ADDENDUM 1
TO
Town of Rosman and City of Brevard Waterline Interconnect
DWI Project Number SRP-D-ARP-0028

This Addendum No. 1 is issued this the 10th day of September 2024 to all parties who hold a set of Bid Documents for the project entitled: "Town of Rosman and City of Brevard Waterline Interconnect" for Transylvania County. This Addendum 1 shall become part of the Contract Documents and its receipt shall be acknowledged on the bid documents at the time of bidding.

- A. See attached revised Sheets C-1 and C-4. Changes have been clouded and are described below and in other revised documents.

PROJECT NO: TRA012	SHEET NO. C-1
DATE: 09/10/2024	of 5
ISSUE No. C-2

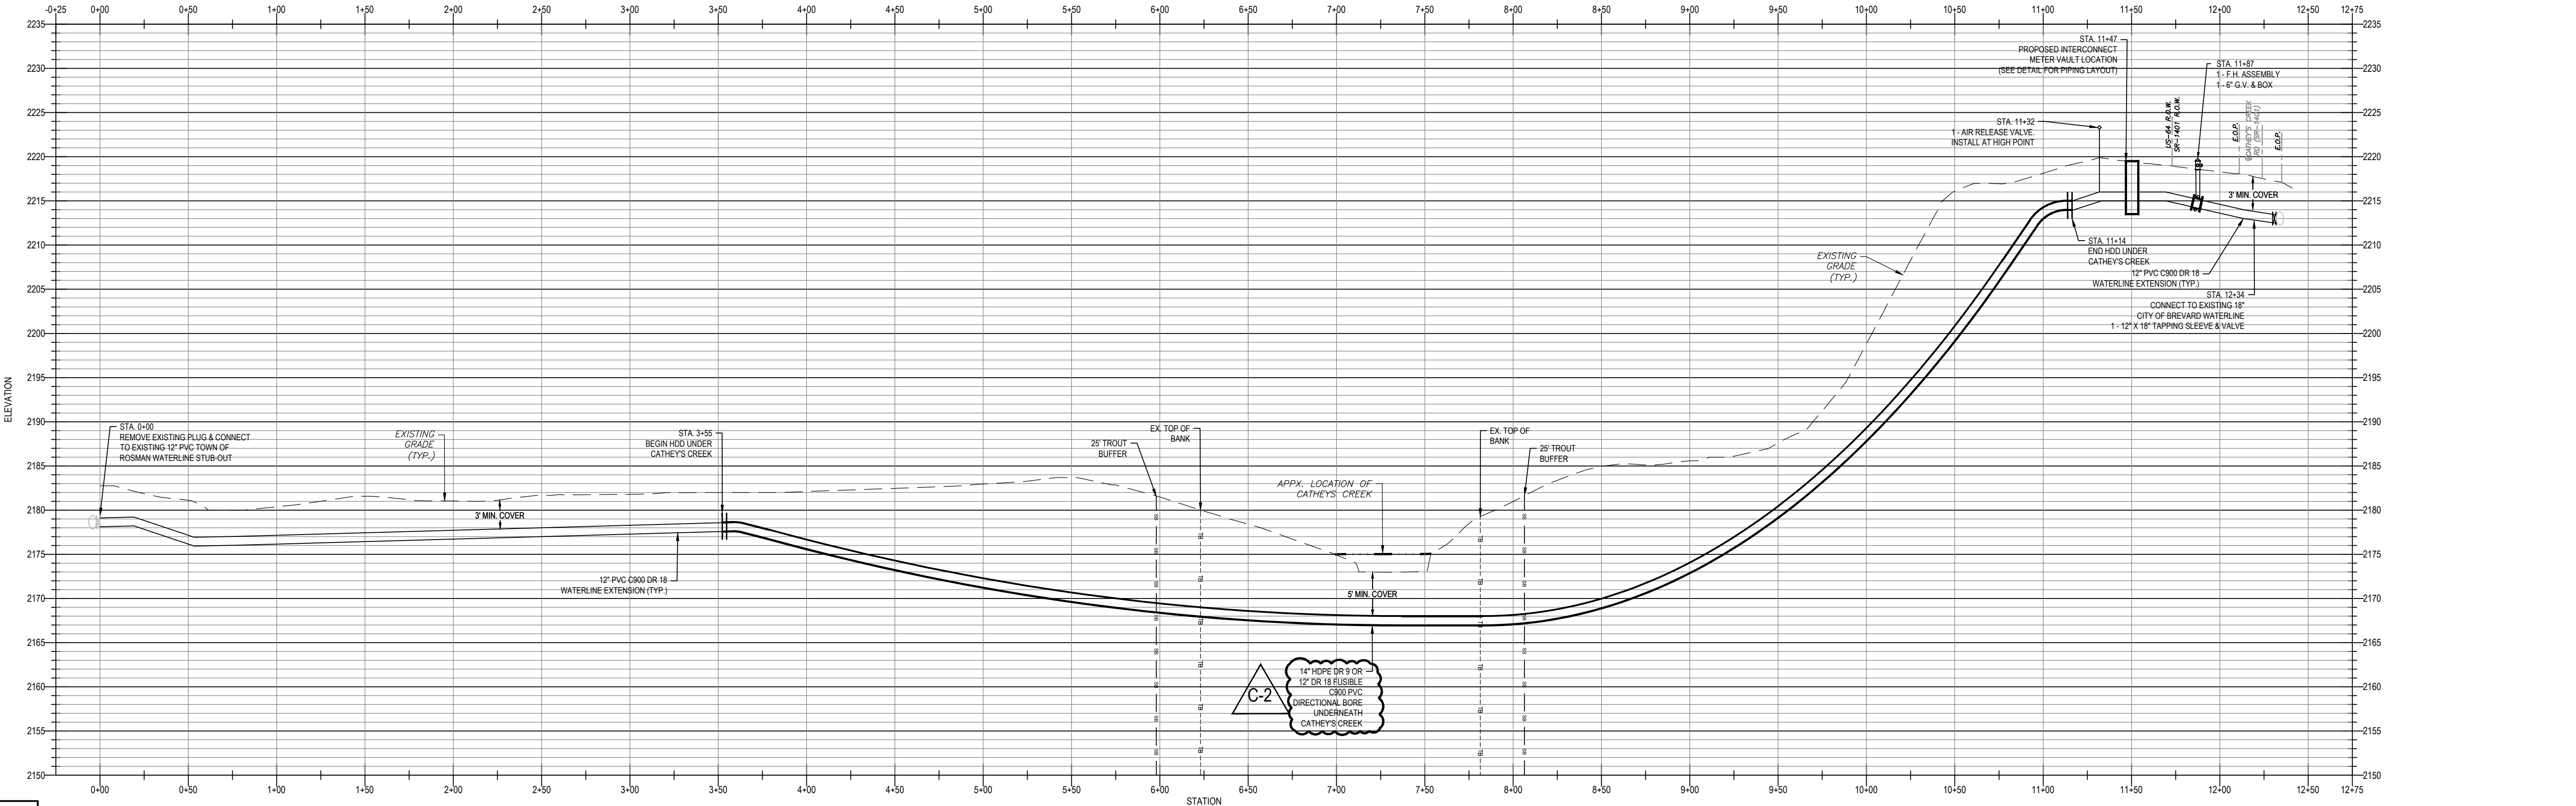
- c. Items 5 & 6 - allowing 12" DR18 fusible C900 PVC as an alternate pipe material.
 - d. Items 5 & 6 - Clarifying that the bore exit must surface within 50' longitudinally and 20' laterally of the location shown on the plans, otherwise the bore will not be accepted.

PROJECT NO. TRA012		SHEET NO. C-4	
DATE: 09/10/2024		of 5

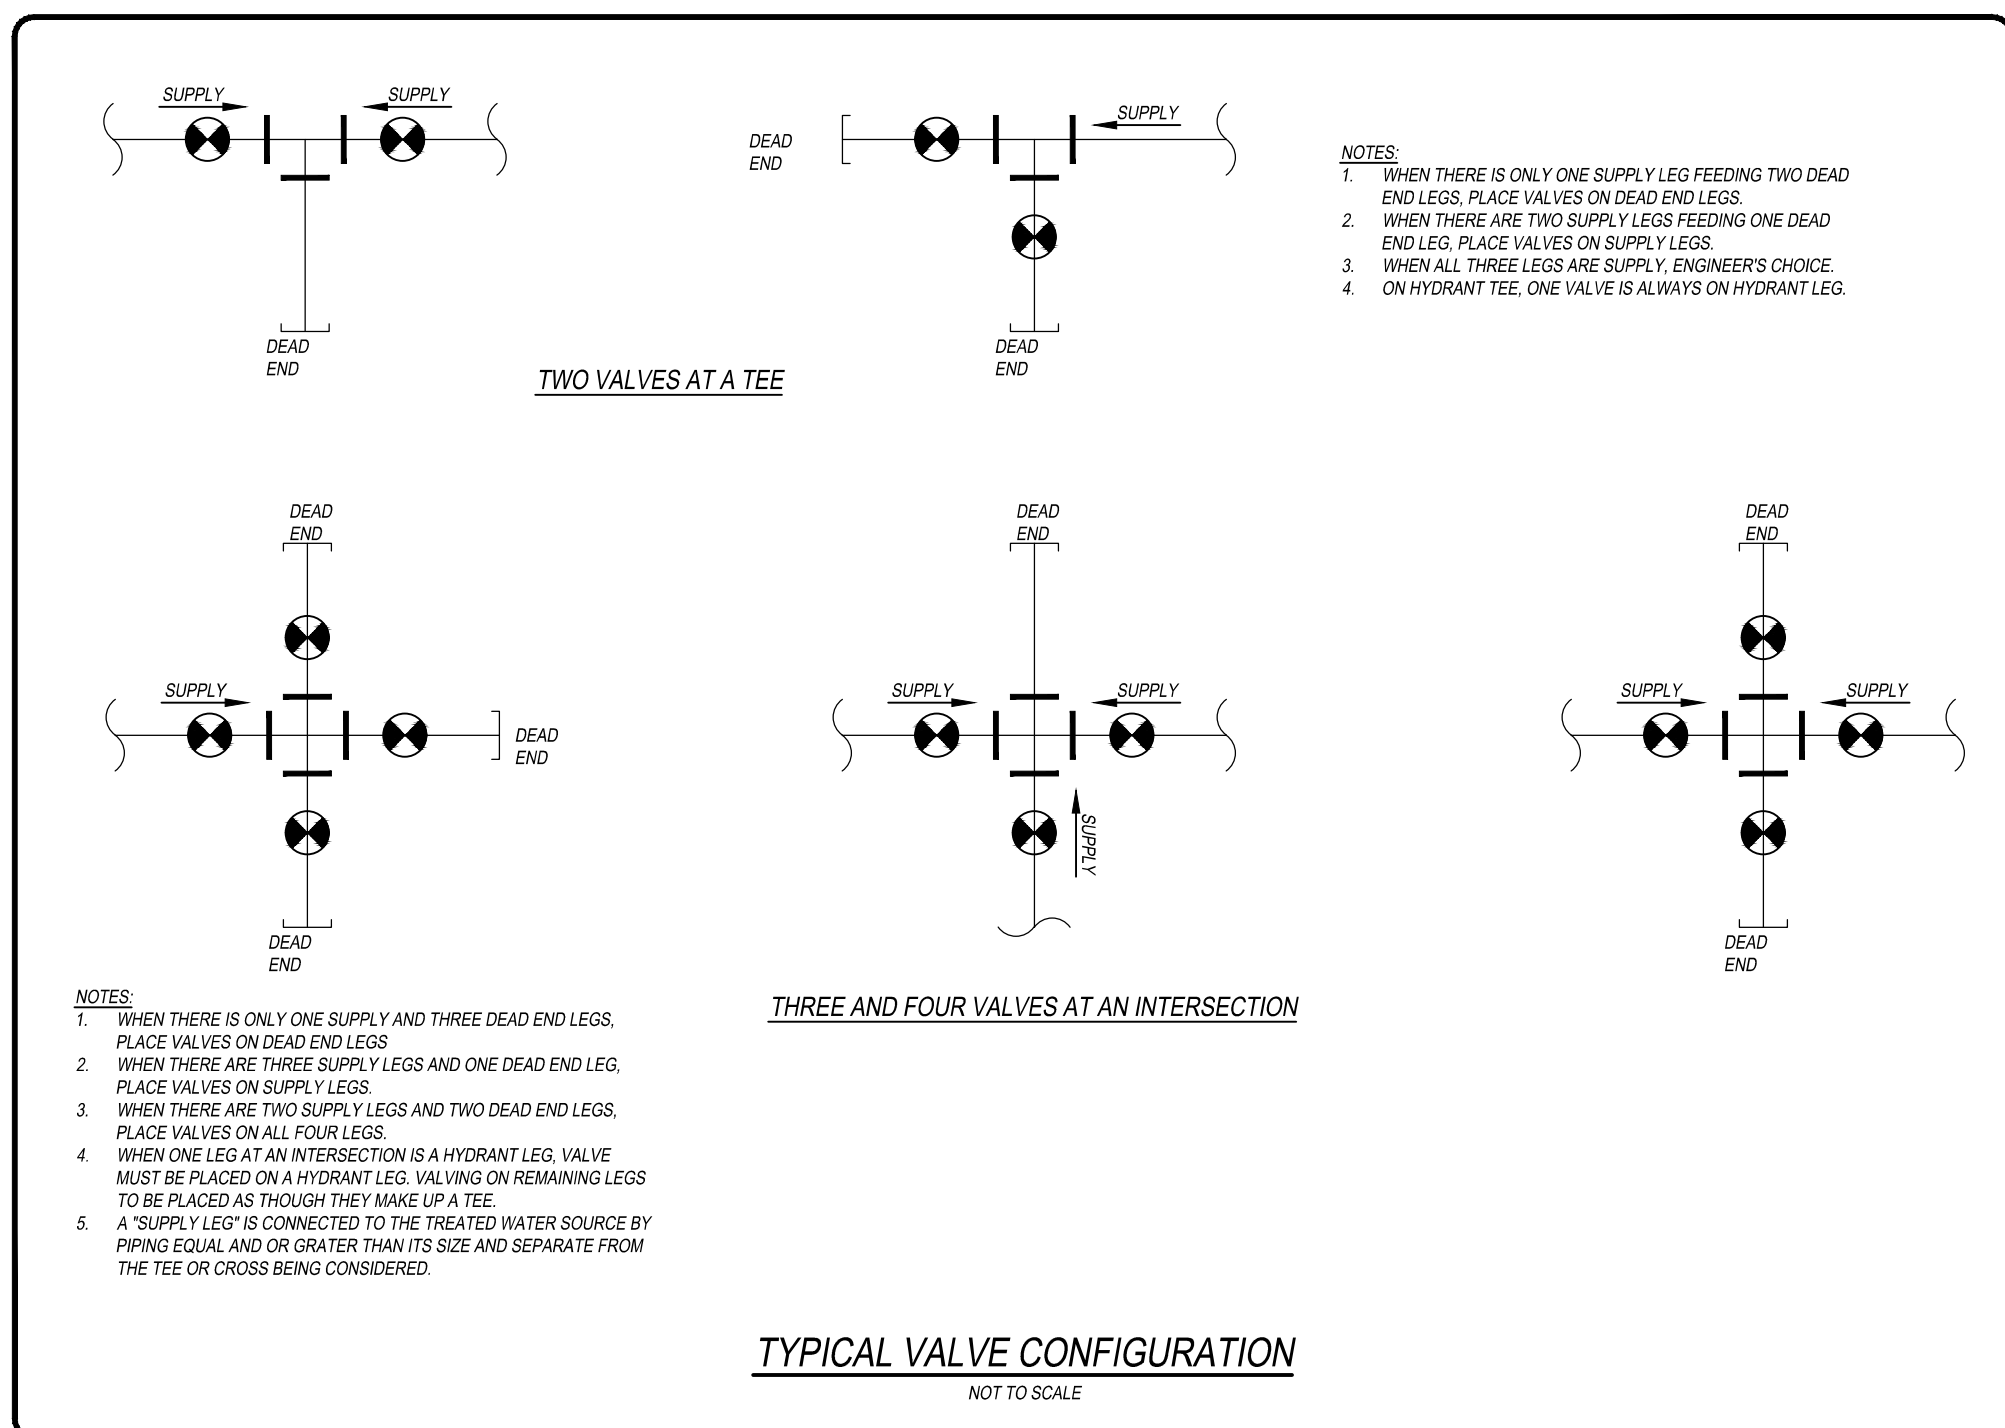
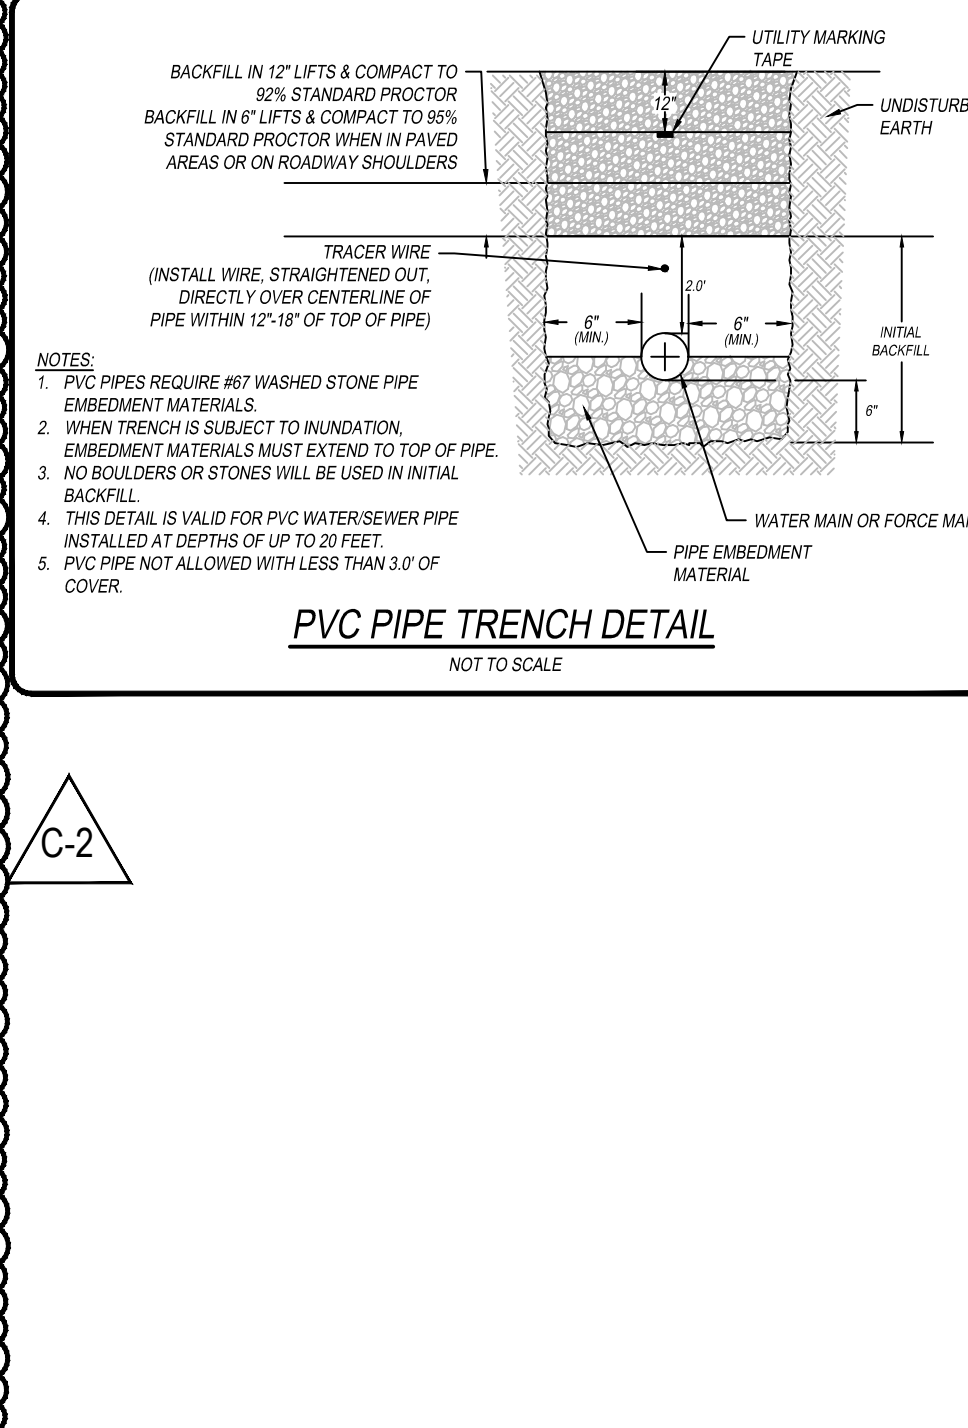
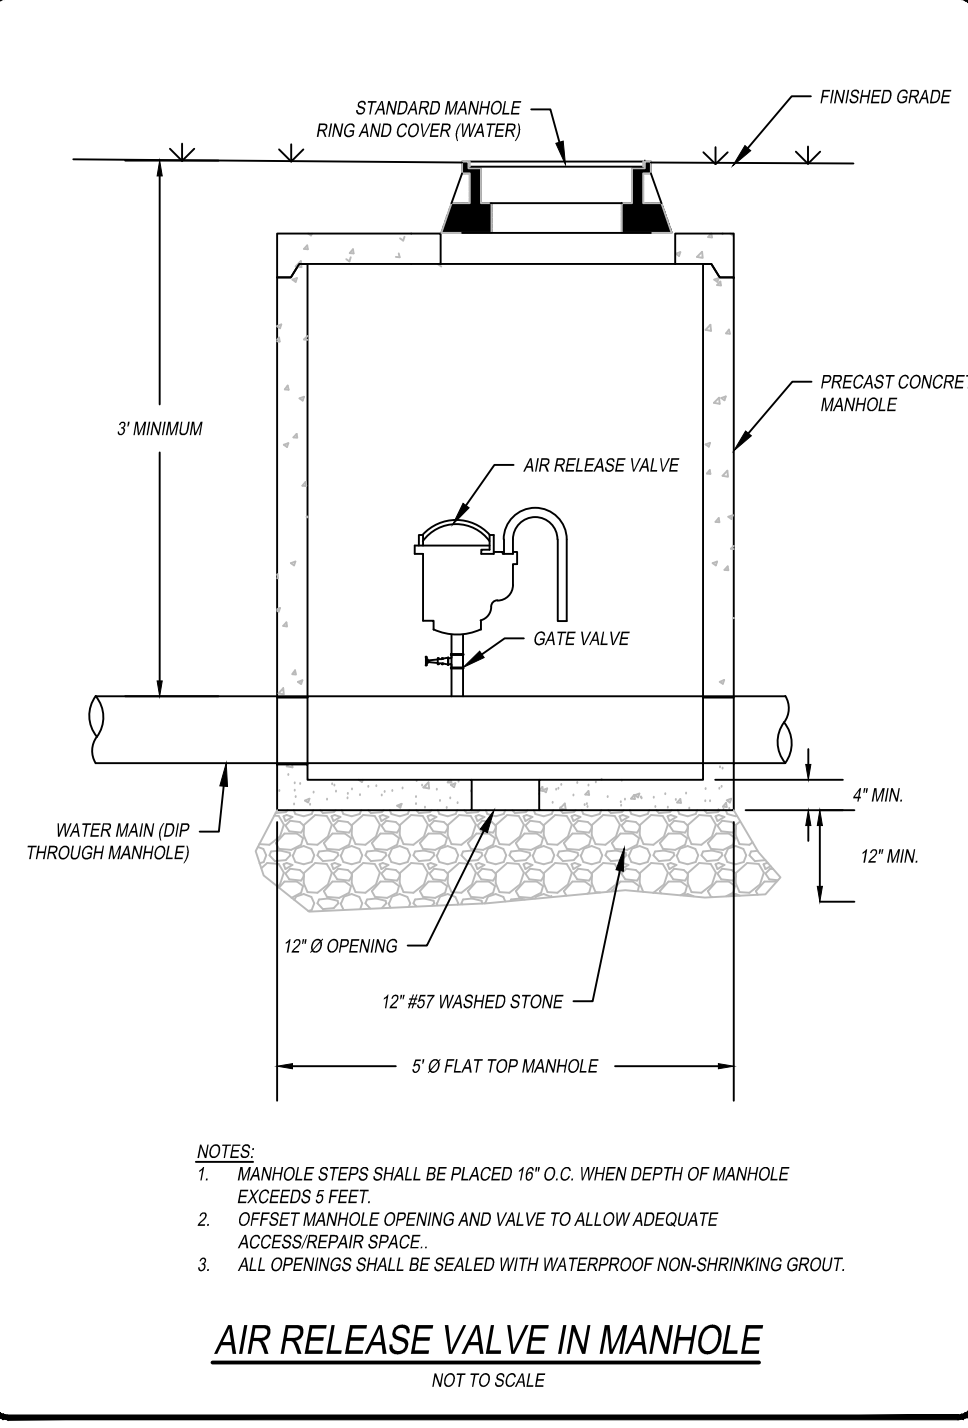
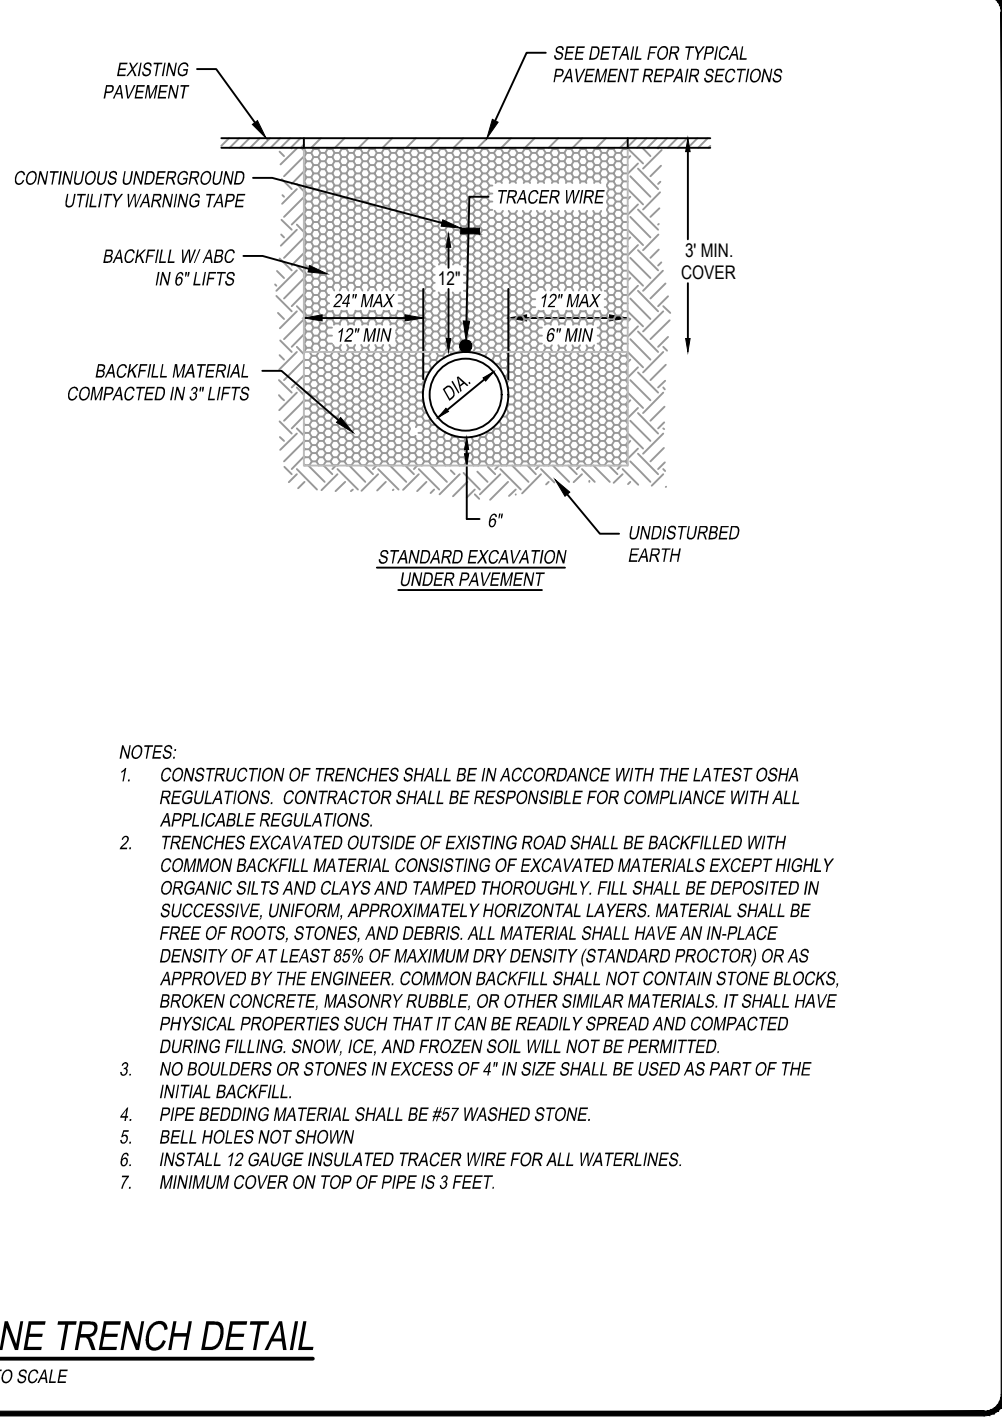
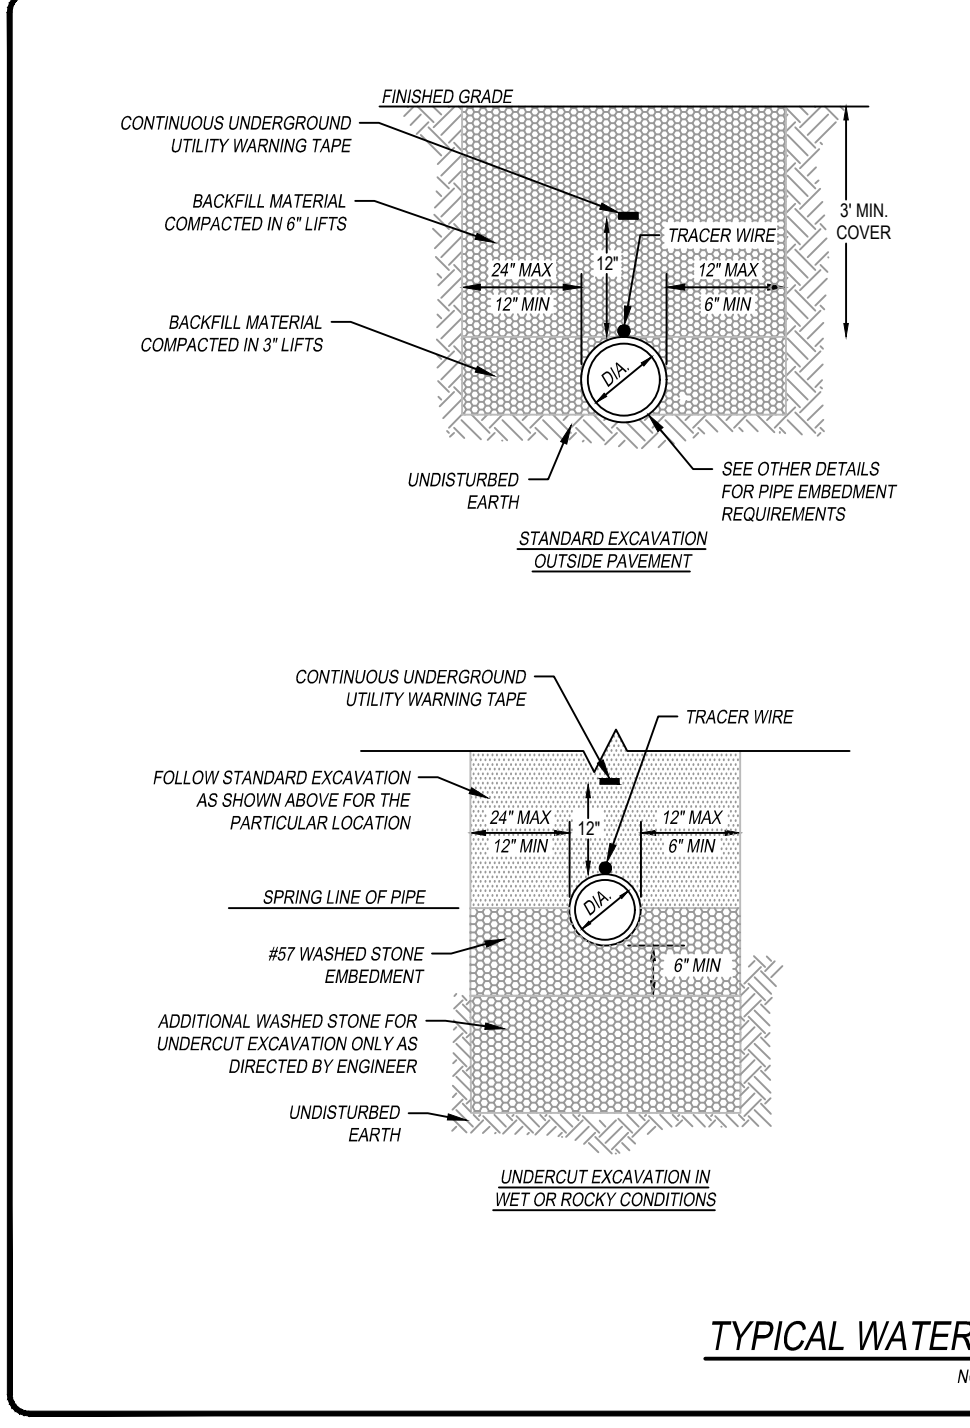
- f. Item 14 - removed "meter box" from description. ARV shall be installed in a manhole per revised detail on Sheet C-4.

- 4) Is the 2" air release to be installed in meter box or manhole?

Answer: Manhole. See revised detail on Sheet C-4.
